HRS DRAWING FOR REFERENCE

| DRAWING NO. | EDC-150568-71-00 |
| PART NO.    | FX8-140P-SV(71)  |

【Precaution】

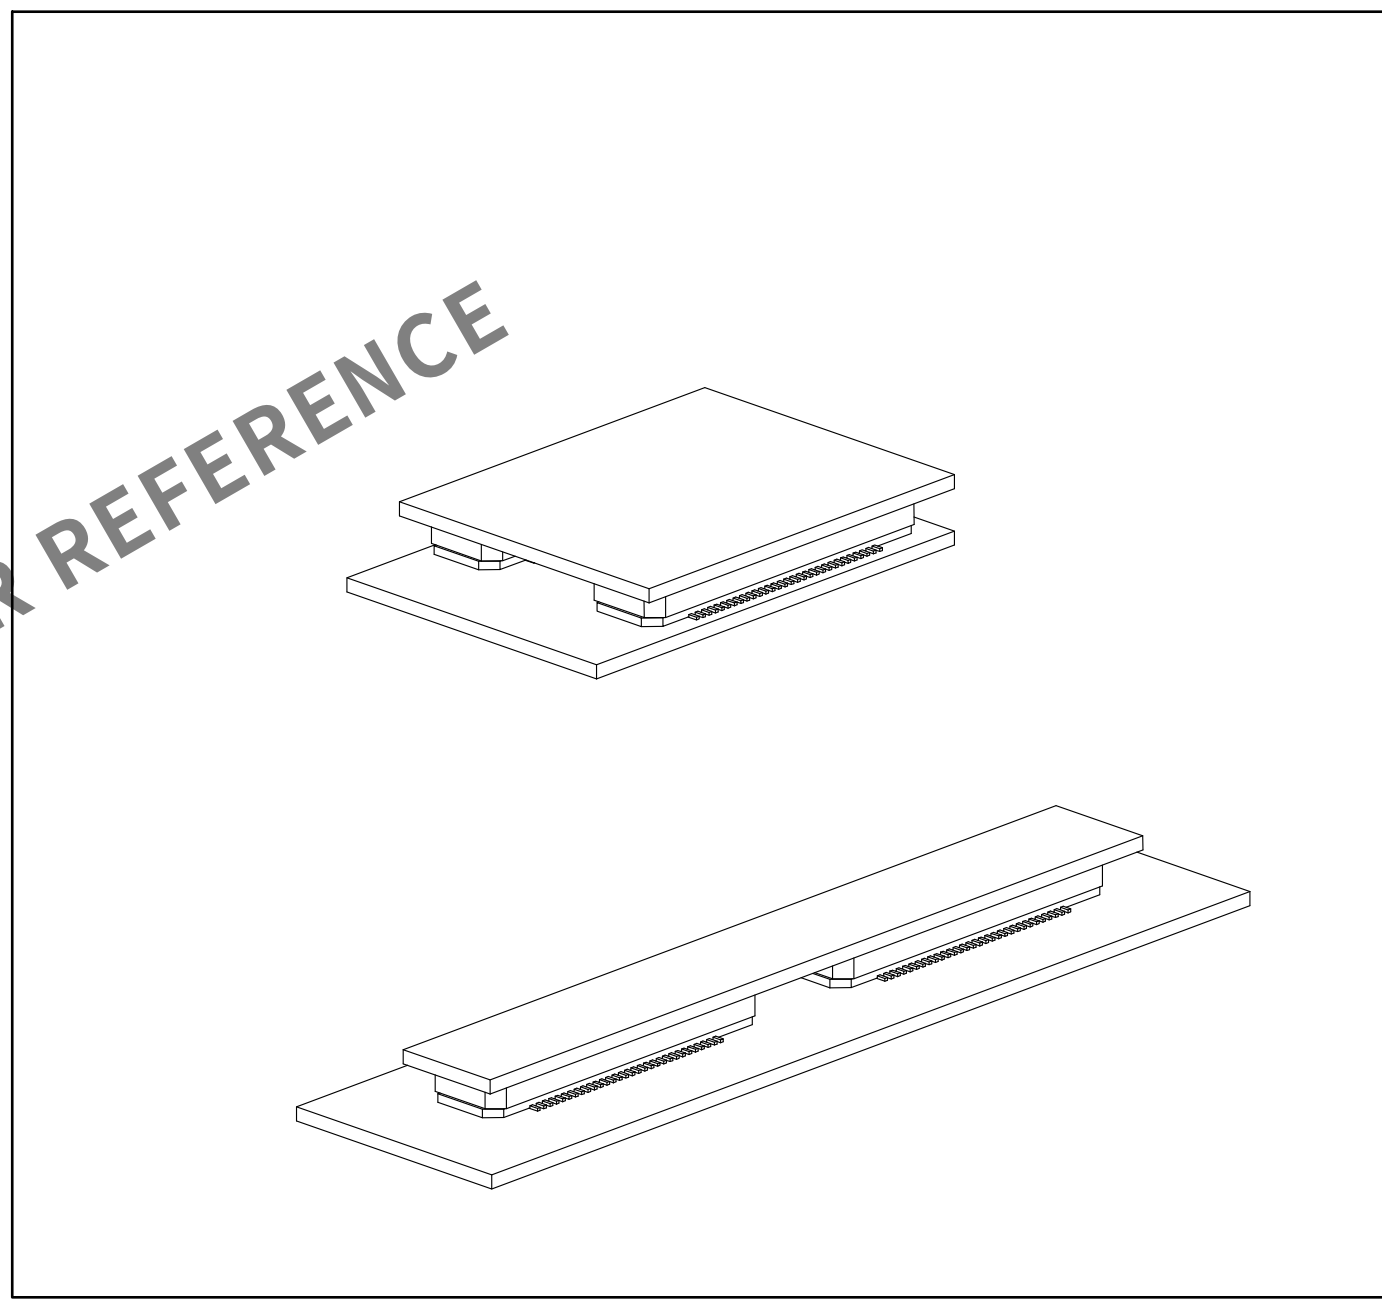
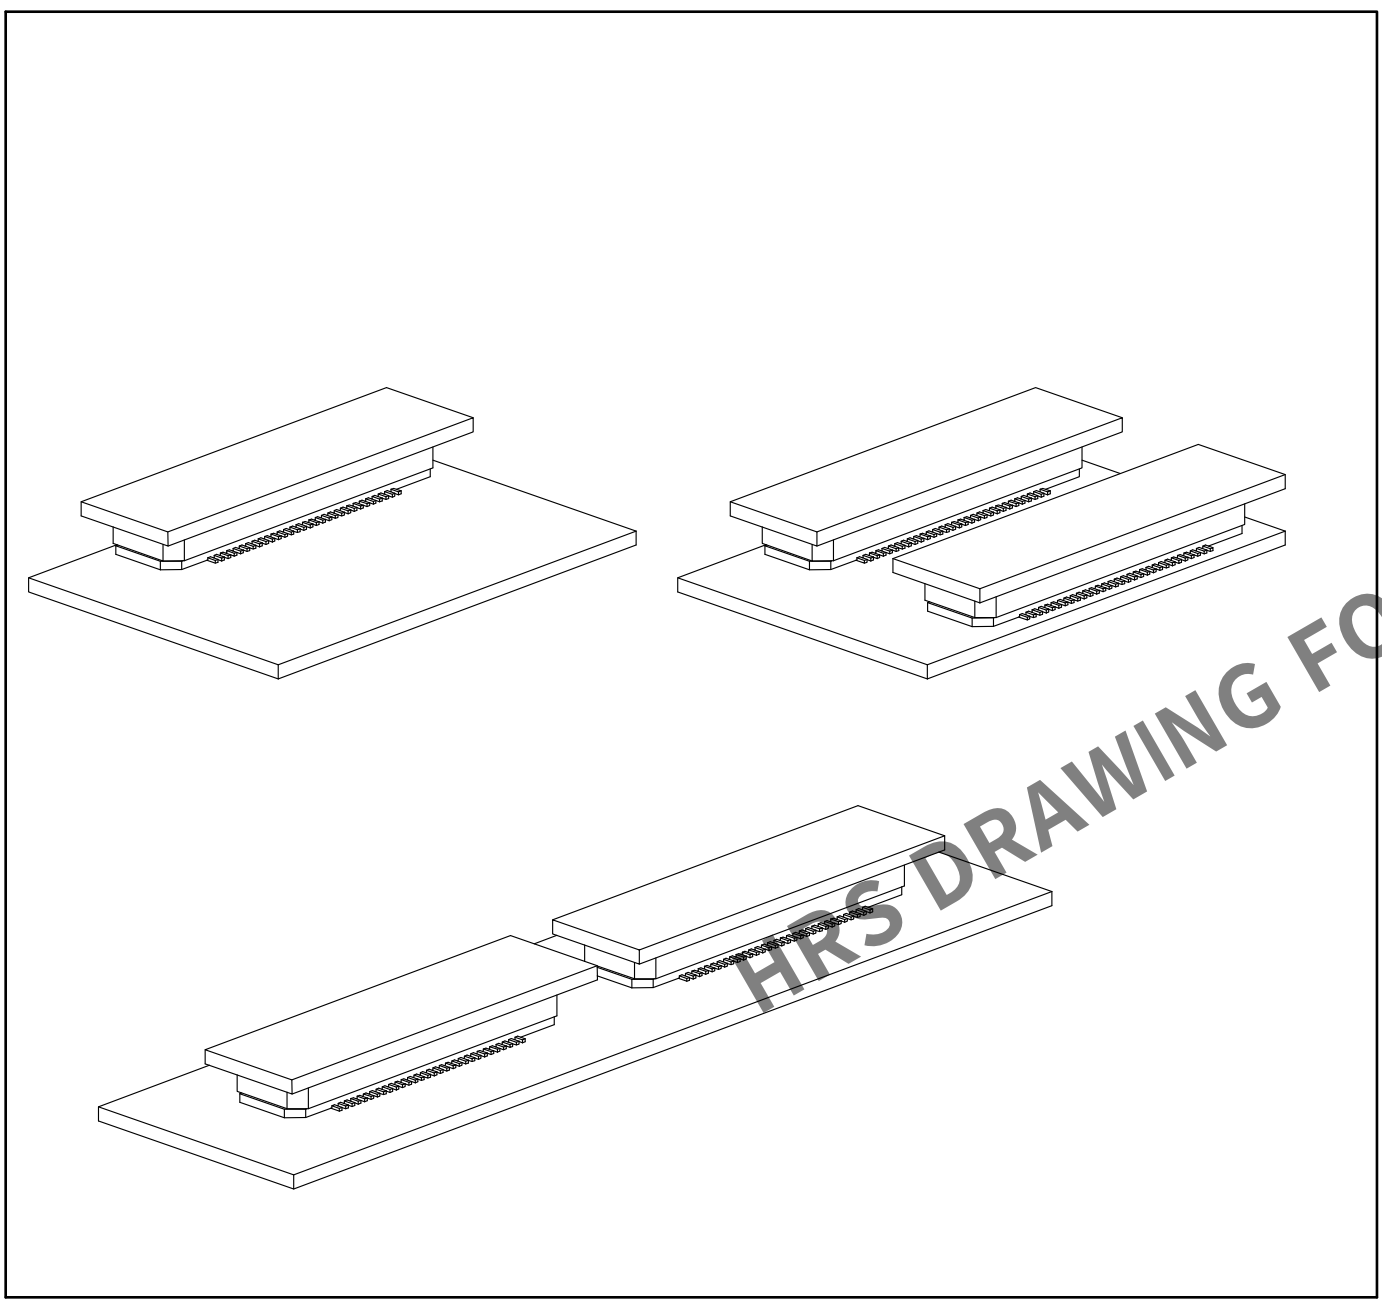
△<sub>1</sub> Added precaution

When a board with multiple connectors mounted is mated, the connector may be damaged or deformed.  
Please divide one side of the board so only one connector is mated per board.
